Service Campaign Bulletin

Campaign No. 2019080019, November 2019

SUBJECT: **Various Models**
Model Years 2012-2017

Replace Steering Gear Bolts

Figure 3

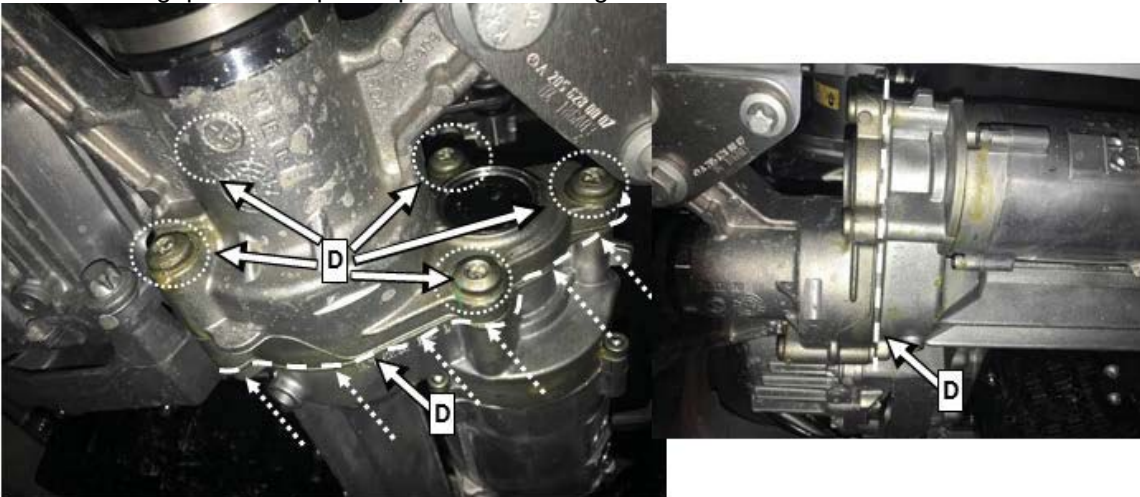
5. After replacing the screws, apply a generous coat of wax to the area (**D, Figure 3**) around the screw heads, screw ends, and the gap between the power-pack and the steering.

- i** Wax gap between power-pack and steering **all-round**.

Figure 6

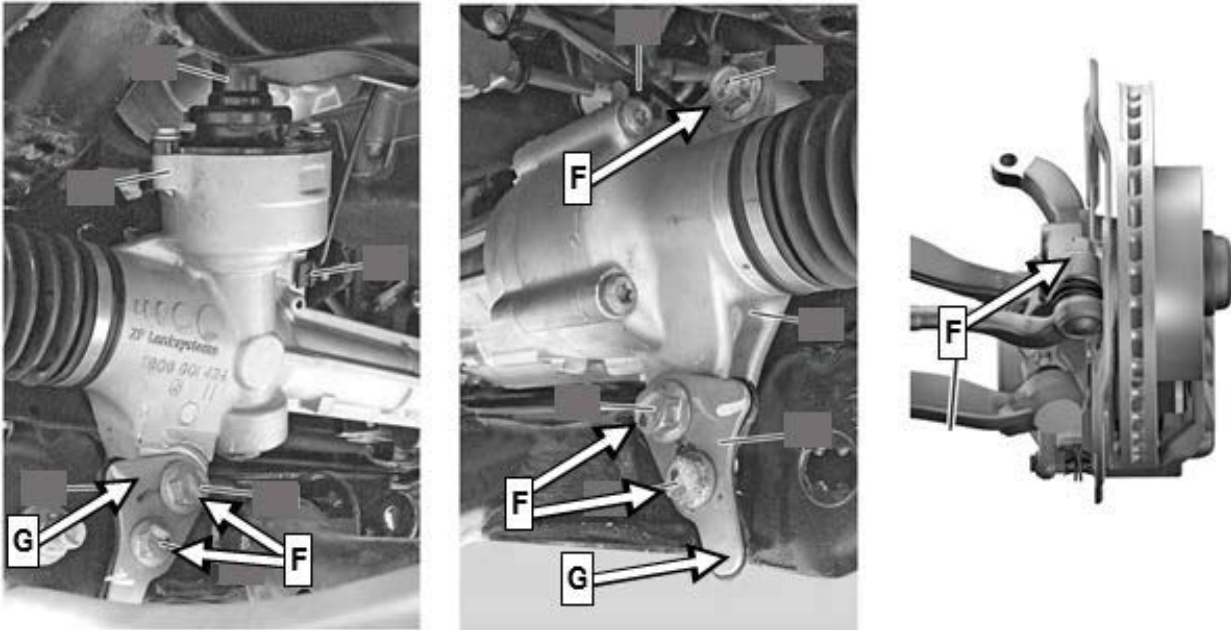
3. Unscrew steering from front axle carrier and tie rods at the steering knuckles (**F**, **Figure 6**).

- i** Steering coupling to steering column is **NOT** released.
- i** For basic data, see **AR46.20-P-0600GQ** and **AR46.40-P-0200EW**
- i** Additional threaded connections do not have to be released.
- i** Remove retaining plates (**G**, **Figure 6**).

Figure 7

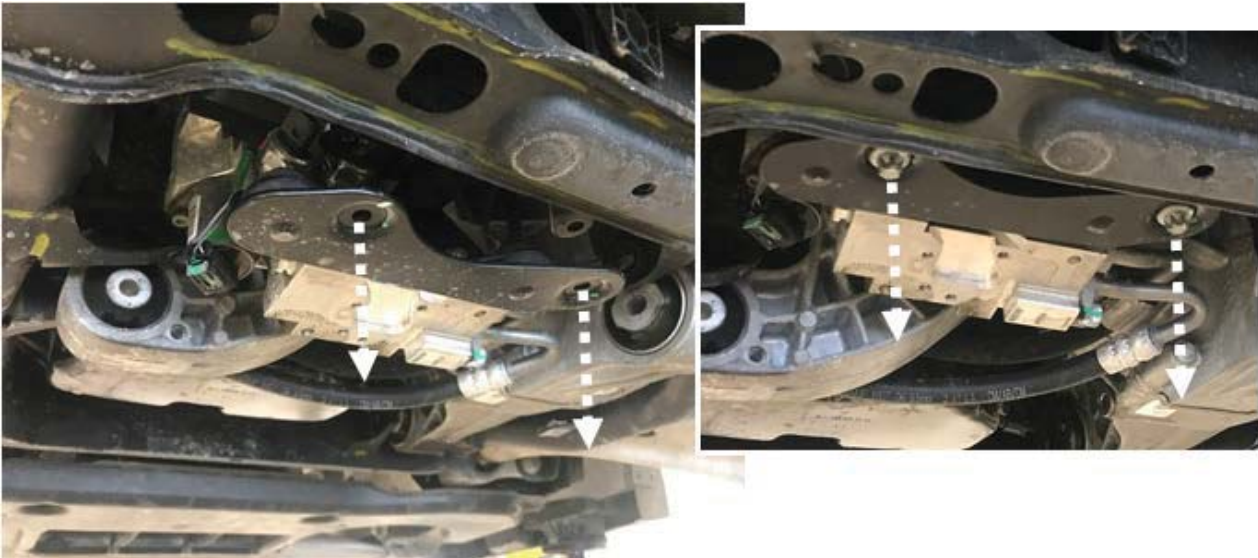
4. For vehicles **with code 468 (Active Curve System)**, unscrew the hydraulics block (**Figure 7**) and slightly press downwards with lines connected.

Figure 8

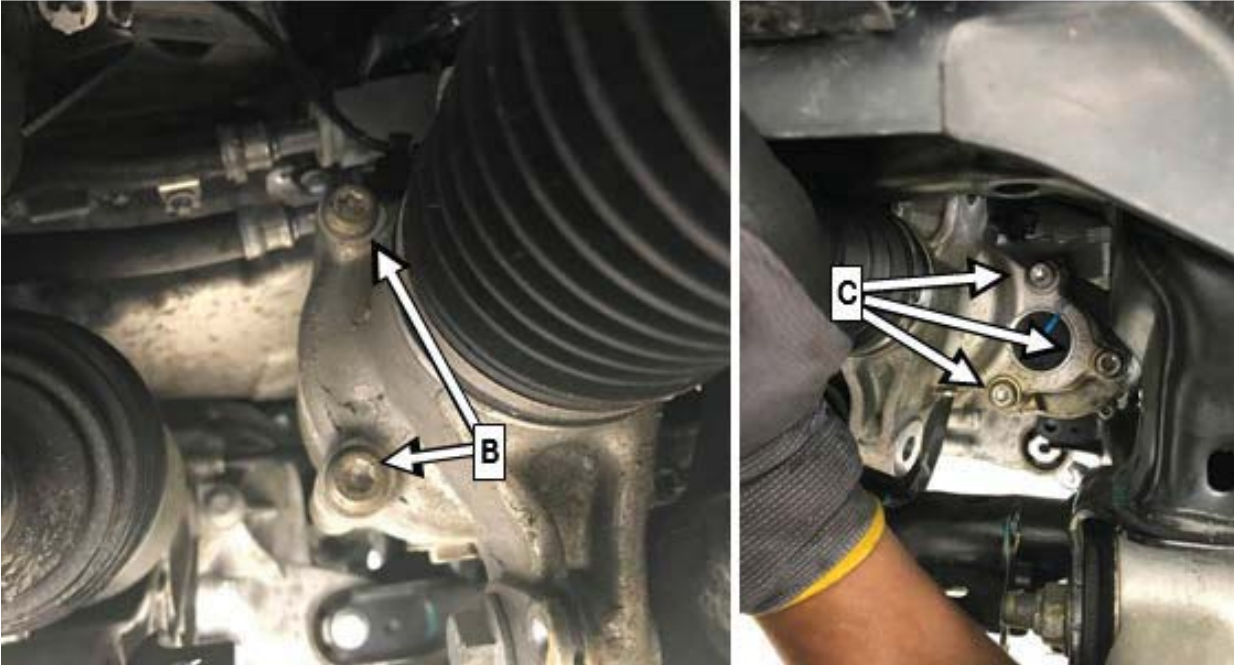
5. Slightly lift steering on left and right and move towards rear in front axle carrier so that the screws (**B and C**, **Figure 8**) are accessible.

6. Remove screws (**B and C, Figure 8**), making **absolutely sure** to do so **individually and one after the other**, replace with new steel screws and tighten with the specified torque incl. tightening angle.

- i** The procedure must be complied with so that the power-pack does not twist away from its set position thus resulting in consequential damage.
- i** **Important:** Take into account the different screw lengths of screws B and C in models 166 and 292!

- Nm** Power-pack screw on steering gear: **5 Nm and 90°** tightening angle.
- i** If a **screw** should **break off** or have already broken off, **replace the electric steering rack**.
